L634-
A.08.26

To: **After Sales Official Network**
Subject: **Rework on LH-RH door emergency release cover**
Date: **23/02/2026**
Pages **6**

Campaign name:
Rework on LH-RH door emergency release cover

Model:
Temerario (Only for vehicle with upholstery configuration)

6.1. With "Dinamica" door panel finish:

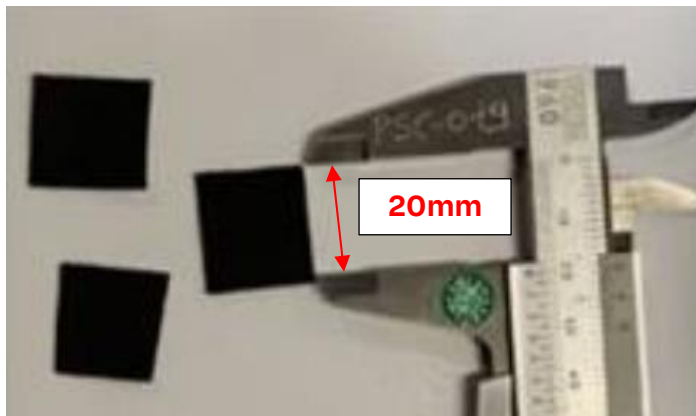
5. Once the emergency release cover (1) has been removed, clean the felt pad bonding area with ISP 1510 isopropanol.

Cut the felt pad code 533.867.910A into 3 pieces. Each piece should measure 20x20 mm. Stick the 3 felt pads together. This will create a packet.

15.1. With "Dinamica" door panel finish:

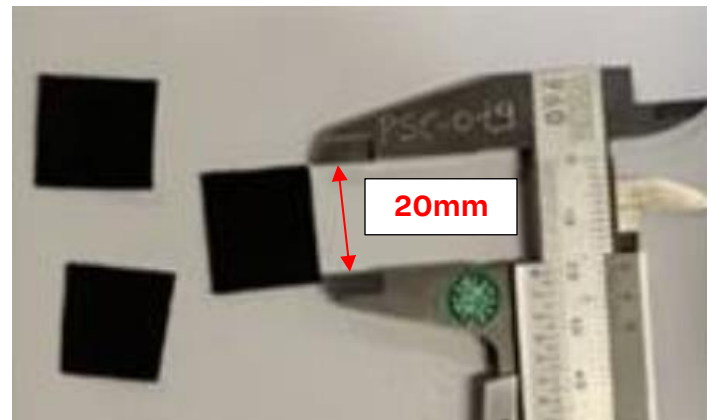
14. Once the emergency release cover (1) has been removed, clean the felt pad bonding area with ISP 1510 isopropanol.

Cut the felt pad code 533.867.910A into 3 pieces. Each piece should measure 20x20 mm. Stick the 3 felt pads together. This will create a packet.
